**CRYSTAL PLACE, RESUBDIVISION OF LOT 2,**  
**RESUBDIVISION OF LOT 15**

APPLICATION NUMBER 1 DATE October 19, 2006

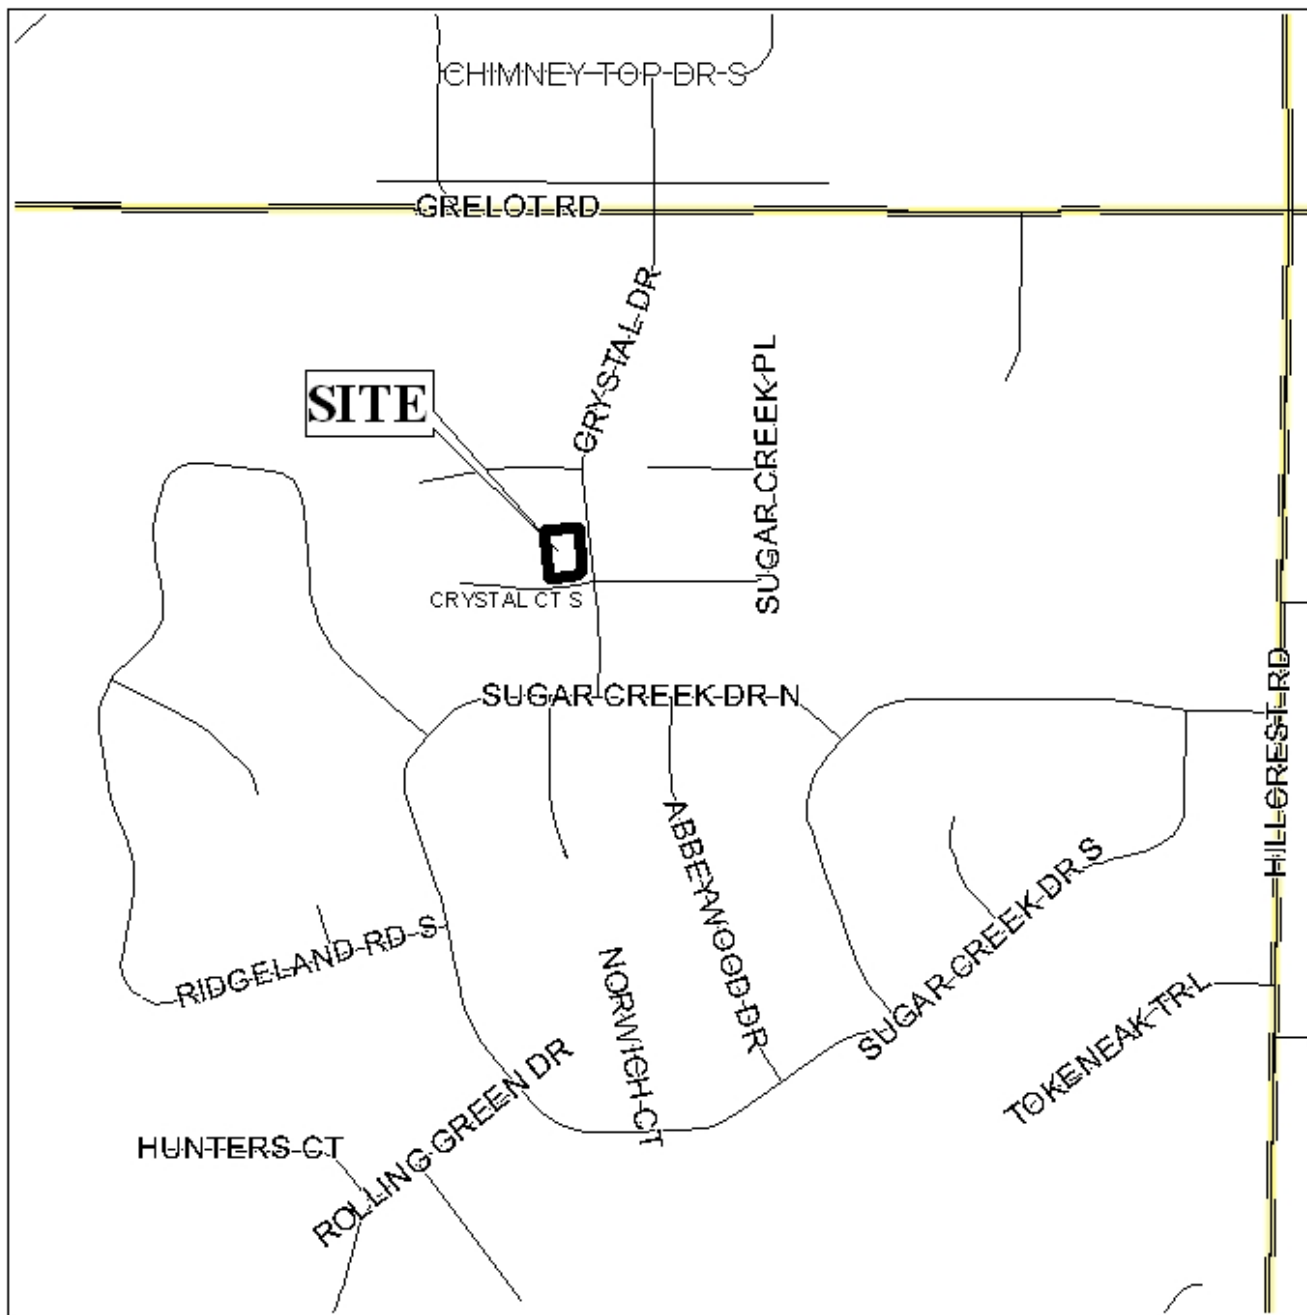
Engineering Comments: Must comply with all stormwater and flood control ordinances. Any work performed in the right-of-way will require a right-of-way permit.

Traffic Engineering Comments: Driveway numbers, size, location and design to be approved by Traffic Engineering and conform to AASHTO standards.

Urban Forestry Comments: Property to be developed in compliance with state and local laws that pertain to tree preservation and protection on both city and private properties (State Act 61-929 and City Code Chapters 57 and 64).

Fire Department Comments: All commercial projects shall comply with the 2003 International Fire Code and Appendices B through G as adopted by the City Of Mobile on July 6, 2004. All One- or Two-Family residential developments shall comply with Appendices B, C and D of the 2003 International Fire Code as adopted by the City of Mobile on July 6, 2004.

The purpose of this application is to remove a condition of the original subdivision, which denied the lot direct access to Crystal Drive. The site has frontage on Crystal Drive and Crystal Court South, both of which have 50-foot rights-of-way.

The purpose of the original condition was to limit curb cuts to corner lots, and the restriction applied to the main street in the development. This is done for two reasons: to reduce traffic complications in the subdivision resulting from excess curb cuts; and to increase the land area available for landscaping.

The present application does not indicate whether they will seek access to both streets, which would not be recommended. However, substitution of one point of access (on Crystal Drive) for another (on Crystal Court South) would be appropriate.

Based on the preceding, the plat is recommended for Tentative Approval subject to the following condition: 1) the placement of a note on the final plat stating that the site is limited to a single curb cut to be approved by Traffic Engineering.
